OVER THE SOLDERING IRON

RCA VICTOR

SERVICE DIVISION - RCA MANUFACTURING CO., INC. - CAMDEN, N. J. - JULY 15, 1938

MOUNTING WASHERS - MODELS 5M2 and 5M4

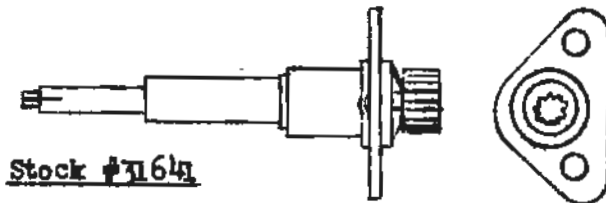
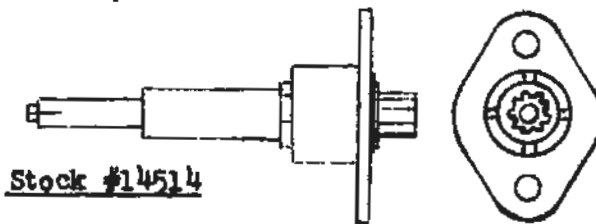
The large flat washer and two lockwashers originally supplied for mounting of the external speaker, are being omitted in some outfit packages, and substituted by two special type washers which are suitable for the same purpose.

NEEDLE SCRATCH - MODEL U-134

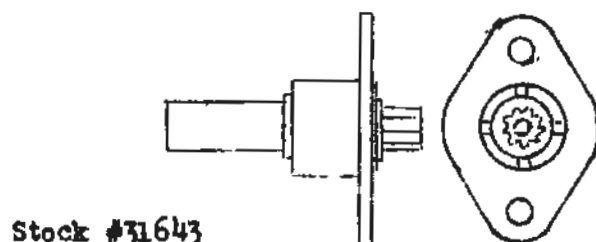
Capacitor C-102, .025 mfd., associated with the H-F Tone control switch may be of the wrong value, in some cases, and "needle scratch" on phonograph reproduction will be excessive. Use of the new "Red Seal" needles will contribute appreciably to reduction of "needle scratch".
